Public Comment Letters received on the  
Public Review Draft Urban Core Specific Plan  
(April 2006)

## RECOMMENDATIONS WITH REGARD TO THE PRESENT "URBAN CORE SPECIFIC PLAN"

Re: Comments to draft Urban Core Specific Plan

In response to the City of Chula Vista's request for public comment to the draft Chula Vista Urban Core Specific Plan, dated April 2006, Carrier Johnson offers the following general and specific comments associated with the draft plan based upon our planning investigations within several of the proposed sub-districts.

## V-1 East Village

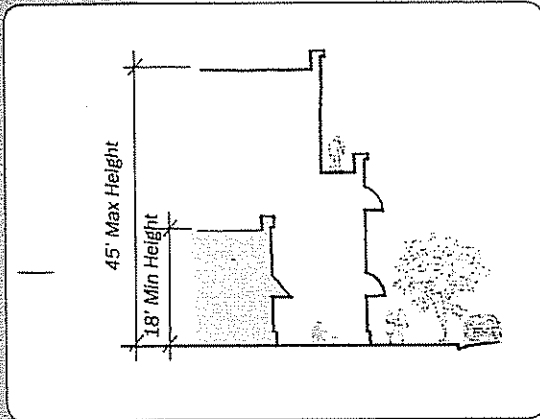
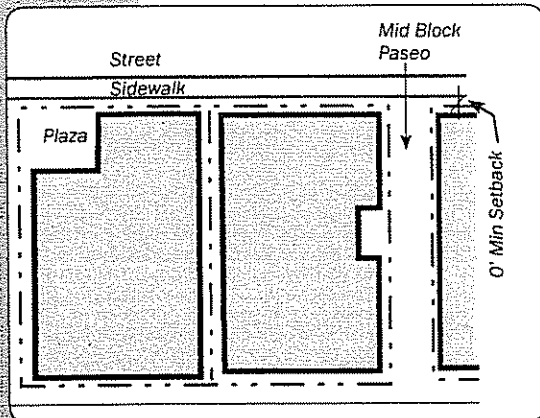
1. **Floor Area Ratio:**  
Min: 1.0      Max: 2.0
2. **Lot Coverage:**  
Max: ~~90%~~ 75%
3. **Building Height:**  
Min: 18'      Max: 45'
4. **Building Stepback:** Not mandatory
5. **Street Wall Frontage:** 50% Min
6. **Setbacks:**  
Street Min: 0'      Street Max: N/A
7. **Open Space Requirement:** 200 sf/du
9. **Primary Land Uses:**  
Residential: 100%

ADD: (NEIGHBORHOOD TRANSITION  
COMBINING DIST.)

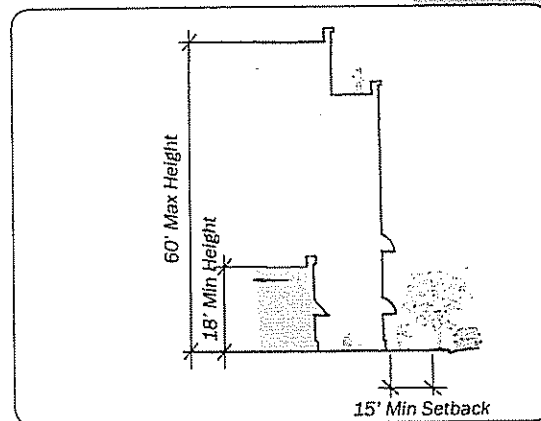
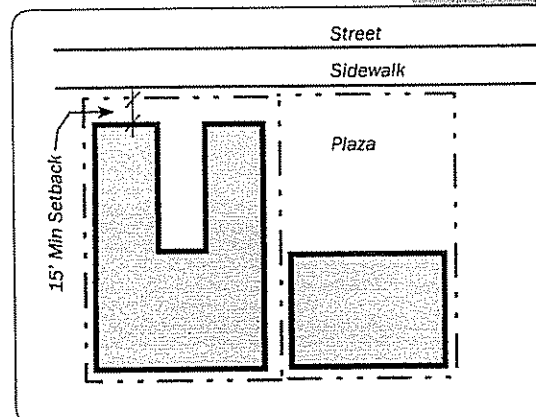
- Floor Area Ratio:**  
Min: N/A      Max: 1.0
- Lot Coverage:**  
Min: ~~45%~~ 40%      Max: ~~80%~~ 60%
- Building Height:**  
Min: 18'      Max: 60'
- Building Stepback:** Not mandatory
- Street Wall Frontage:** N/A
- Setbacks:**  
Street Min: 15'      Street Max: N/A
- Open Space Requirement:** 100 sf/du
- Primary Land Uses:**  
Residential: 100% Max  
Office: 100% Max  
Public/Quasi-Public: 100% Max

## UC-3 Roosevelt

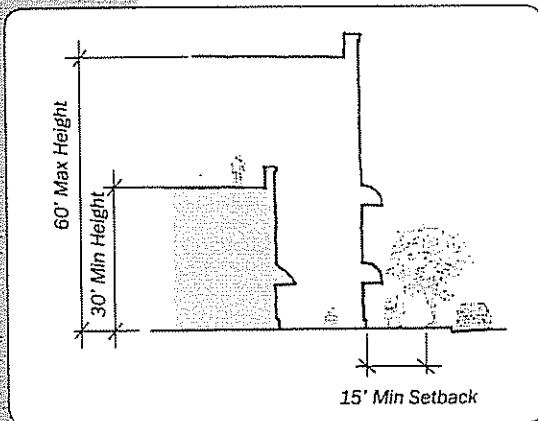
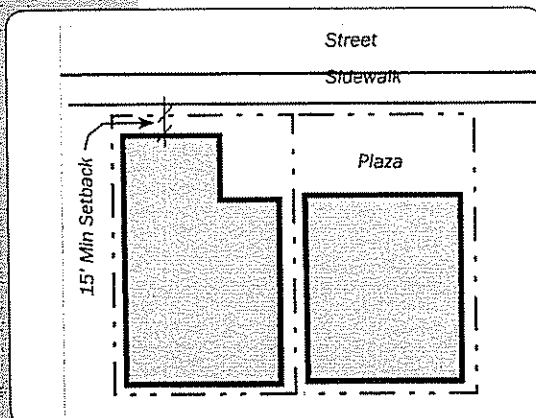
Add: (NEIGHBORHOOD TRANSITION COMBINING DIST.)

Fig. 6.22

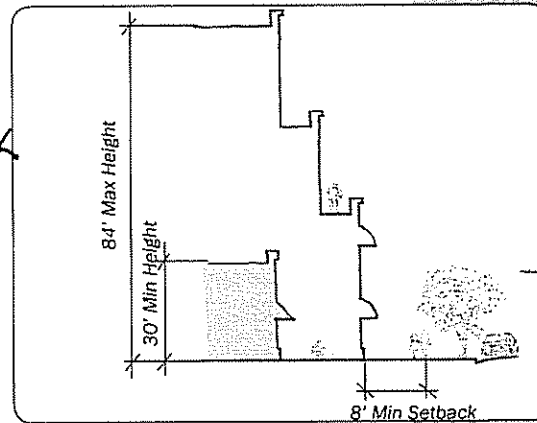
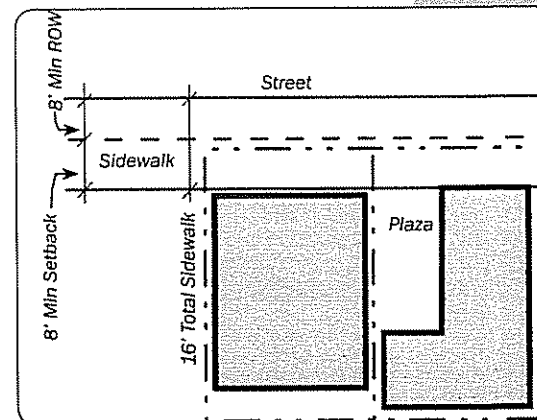
1. **Floor Area Ratio:**  
Min: N/A Max: ~~2.0~~ 3.0
2. **Lot Coverage:**  
Min: 50% Max: 70%
3. **Building Height:**  
Min: 30' Max: 84'
4. **Building Stepback:** Not mandatory
5. **Street Wall Frontage:** 50% Min
6. **Setbacks:**  
Street Min: 8' Street Max: N/A  
(\*Along H Street only to provide total of 16' sidewalk) + 15' BLDG SETBACK FROM SIDEWALK
7. **Open Space Requirement:** N/A
8. **Primary Land Uses:**  
Office: 100% Max  
INSTITUTIONAL: 100 MAX

## UC-5 Soho

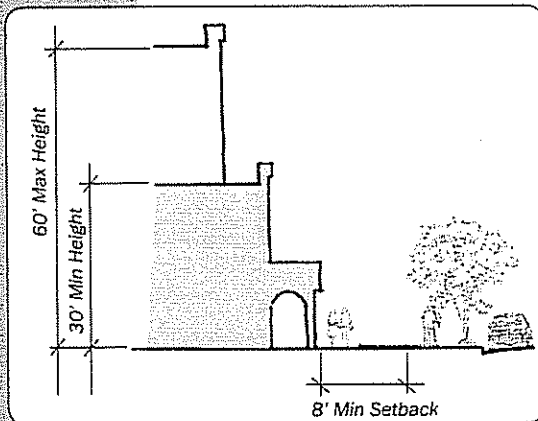
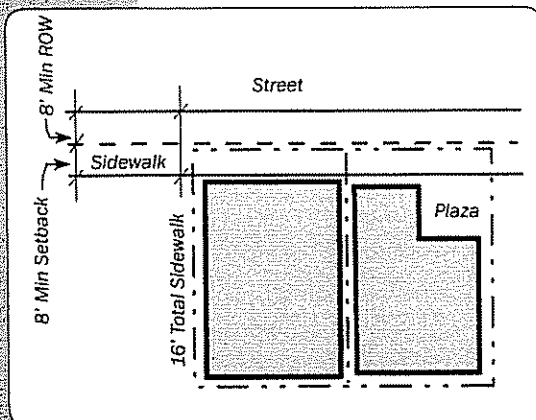
ADD: (NEIGHBORHOOD TRANSITION COMBINING DIST.)

1. **Floor Area Ratio:**  
Min: 1.0      Max: 2.0
2. **Lot Coverage:**  
Min: N/A      Max: ~~N/A~~ 70%
3. **Building Height:**  
Min: 30'      Max: 60'
4. **Building Stepback:** Not mandatory
5. **Street Wall Frontage:** 50% Min
6. **Setbacks:**  
Street Min: 8'    Street Max: N/A  
(\*Along H Street only to provide total of 16' sidewalk)
7. **Open Space Requirement:** N/A
8. **Primary Land Uses:**  
Retail: ~~50%~~ Max 20%  
Office: 100% Max  
Residential: 100% MAX

## UC-9 Mid H Street

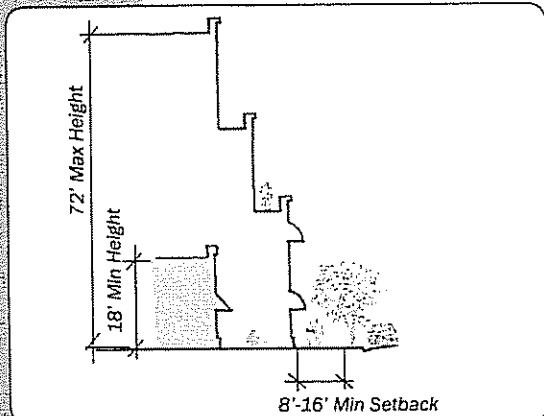
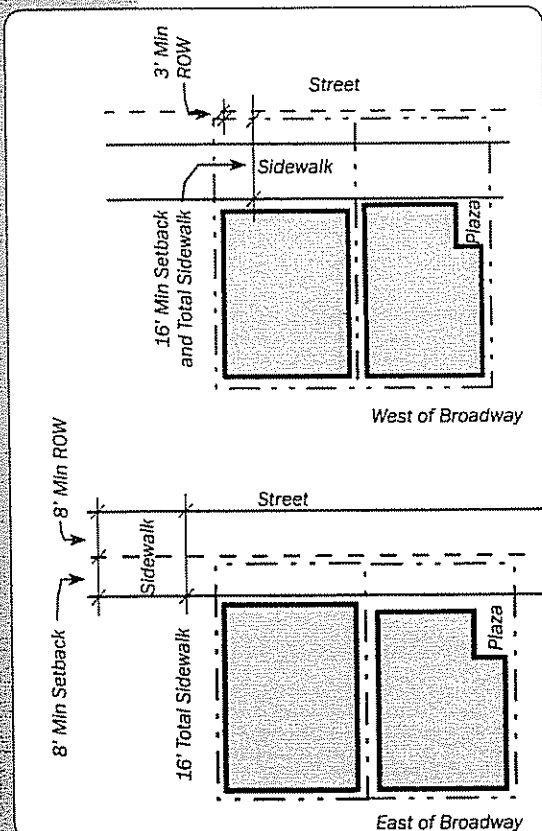
ADD  
REQUIREMENT  
FOR 15'  
BLDG. SET-  
BACK FROM  
SIDEWALK ON  
H St.

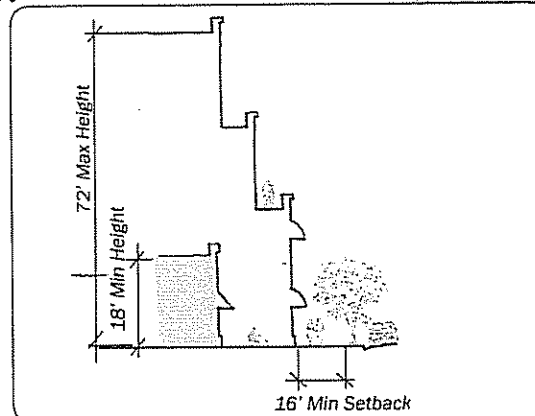
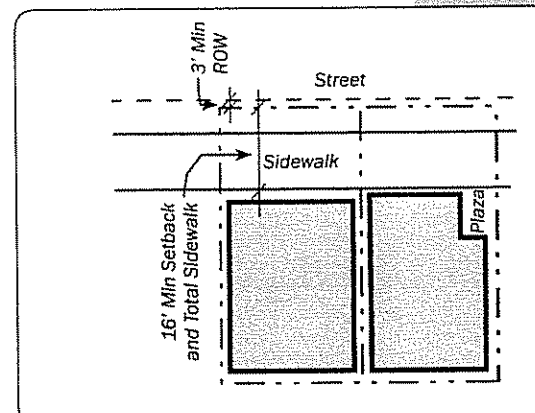
1. **Floor Area Ratio:**  
Min: N/A Max: 10 1.5
2. **Lot Coverage:**  
Min: N/A Max: 80%
3. **Building Height:**  
Min: 18' Max: 72'
4. **Building Stepback:** Not mandatory
5. **Street Wall Frontage:** 50% Min
6. **Setbacks:**  
H Street — 15' BLDG. SETBACK FROM SIDEWALK  
Street Min: 16' Street Max: N/A  
Broadway  
Street Min: 0' Street Max: N/A
7. **Open Space Requirement:** N/A
8. **Primary Land Uses:**  
Residential: 20% Max (Not allowed on Broadway or H Street frontage on ground floor, except for access)  
Retail: 100% Max  
Office: 30% Max (Not allowed on ground floor facade, except for access)

ADD SPECIAL  
REQUIREMENTS  
FOR RESIDENTIAL  
WITHIN 500' I-5

## UC-11 Chula Vista Center West Residential (Neighborhood Transition Combining District)

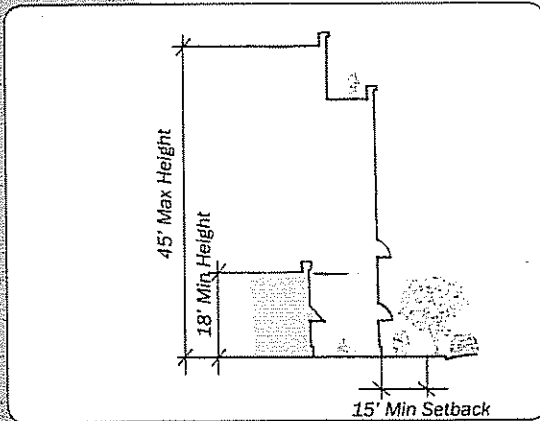
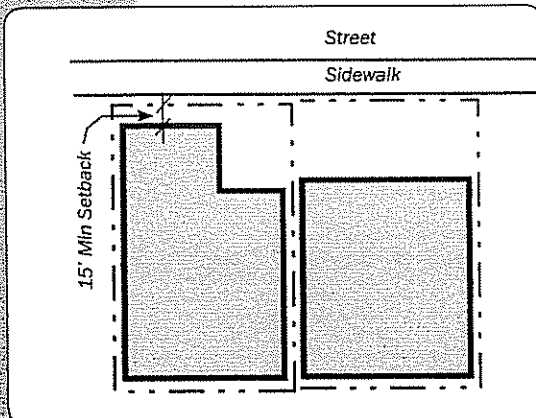
SEE COMMENTS IN  
SUBMITTED PAPER!

Fig. 6.42

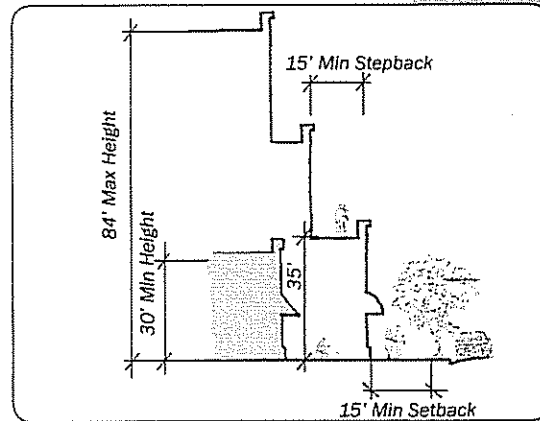
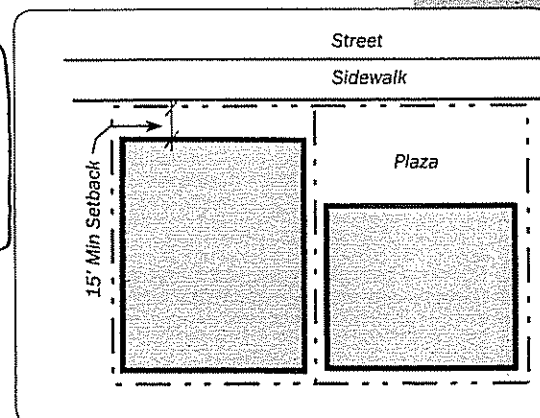
1. **Floor Area Ratio:**  
Min: 1.5      Max: 3.0
2. **Lot Coverage:**  
Min: N/A      Max: ~~80%~~ 70%
3. **Building Height:**  
Min: 30'      Max: 84'
4. **Building Stepback:**  
Min: 15'      At Building Height: 35'
5. **Street Wall Frontage:** N/A
6. **Setbacks:**  
Street Min: 15'      Street Max: N/A
7. **Open Space Requirement:** 200 sf/du
8. **Primary Land Uses:**  
Residential 100% Max

ADD SPECIAL REQUIREMENTS  
FOR RESIDENTIAL ADJACENT  
TO I-5

## UC-15 E Street Trolley (Transit Focus Area)

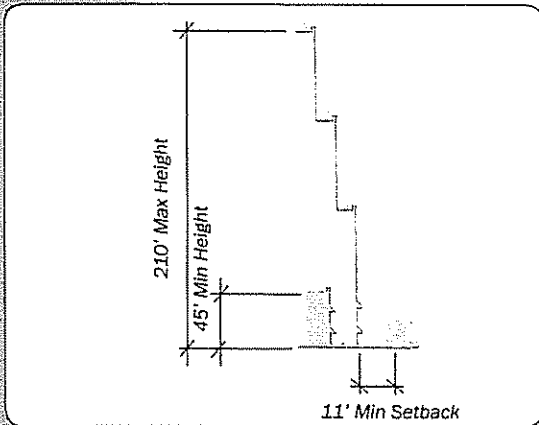
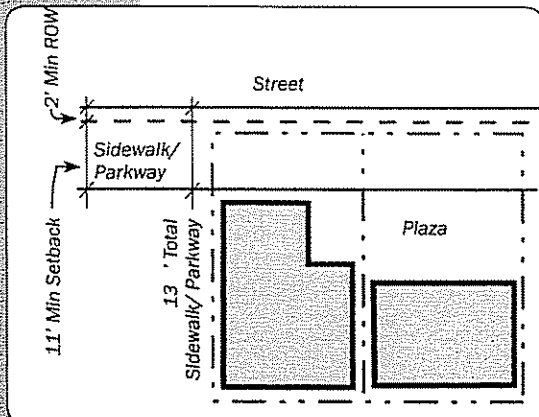
ADD SPECIAL  
REQUIREMENTS FOR  
RESIDENTIAL ADJACENT  
TO I-5 (w/in 500')

Fig. 6.46

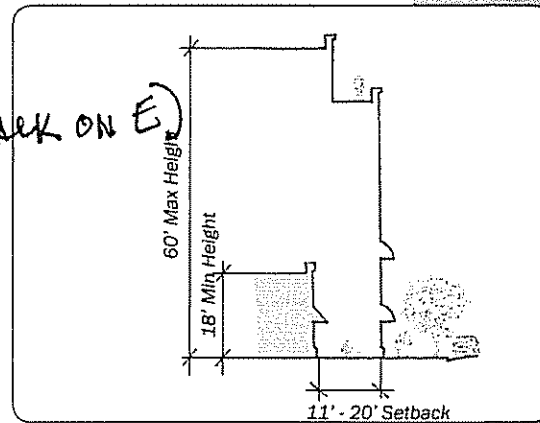
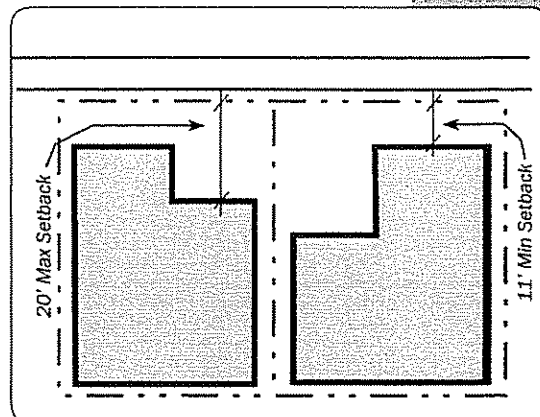
1. **Floor Area Ratio:**  
Min: N/A      Max: 1.0
2. **Lot Coverage:**  
Min: 50%      Max: 70%
3. **Building Height:**  
Min: 18'      Max: 60'
4. **Building Stepback:** Not mandatory
5. **Street Wall Frontage:** 50% Min
6. **Setbacks:**  
Street Min: 11'\*    Street Max: 20'  
(\*Along E Street between I-5 and 300' east of I-5)  
*(ADD 15' SETBACK FROM SIDEWALK ON E)*
7. **Open Space Requirement:** N/A
8. **Primary Land Uses:**  
Retail: 50% Max  
Hospitality: 100% Max  
*ALLOW SOME RESIDENTIAL*

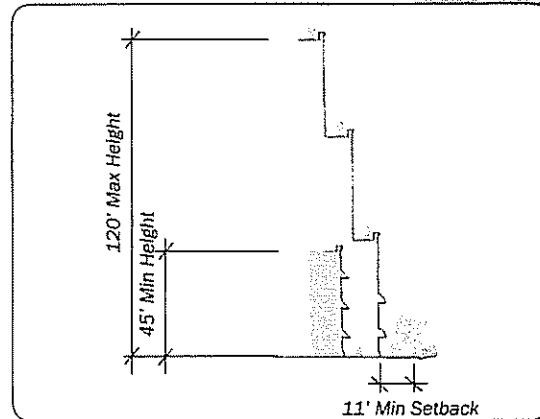
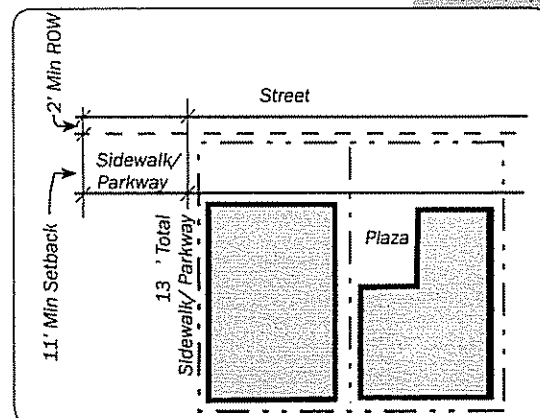
*ADD SPECIAL REQUIREMENTS FOR RESIDENTIAL 500' FROM I-5*

**Fig. 6.54**

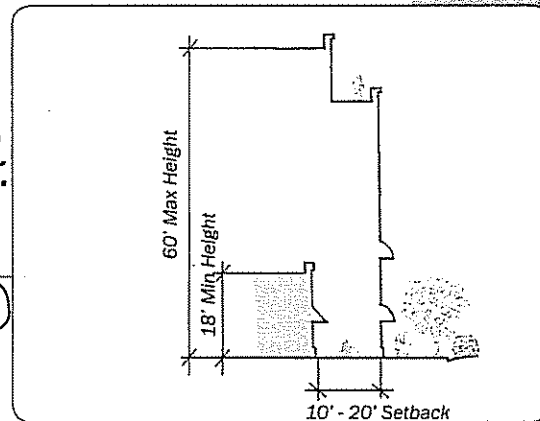
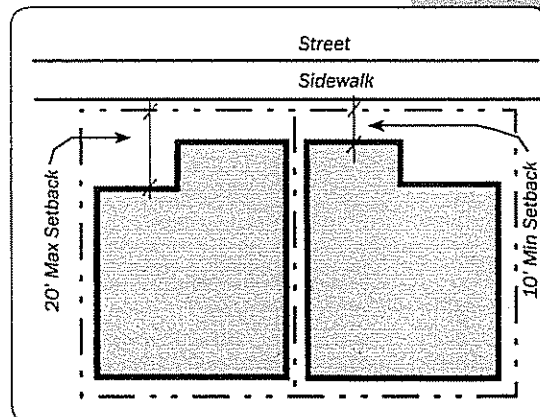
*why?*

~~D. Add some residential~~

## 5. Storefront Design Guidelines

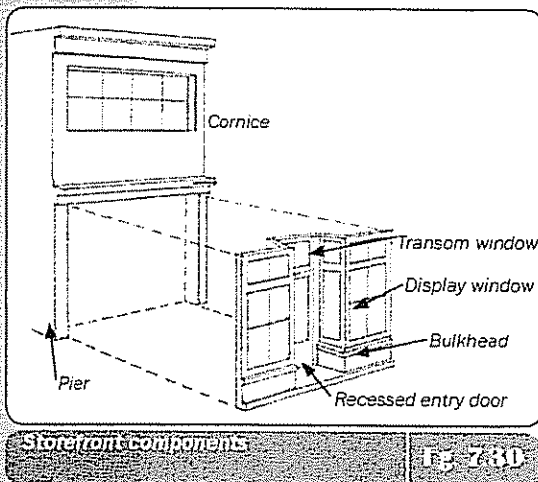
MAKE IT  
"CLEAR THAT"  
"STOREFRONT"  
DG'S APPLY TO ALL  
DEVELOPMENT IN THE  
VILLAGE SUBDISTRICTS,  
NOT JUST STORES.

Fig. 7.43

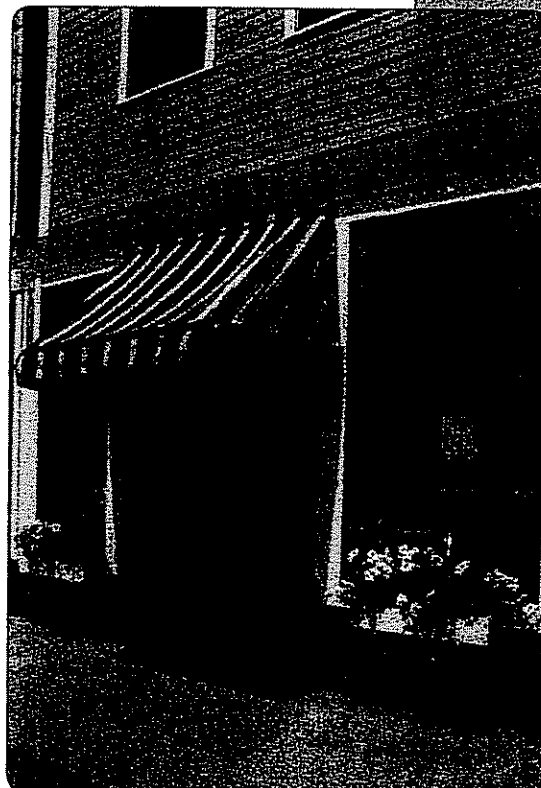
*UNLESS THEY CONFORM TO HISTORICAL BUILDING CODE.*
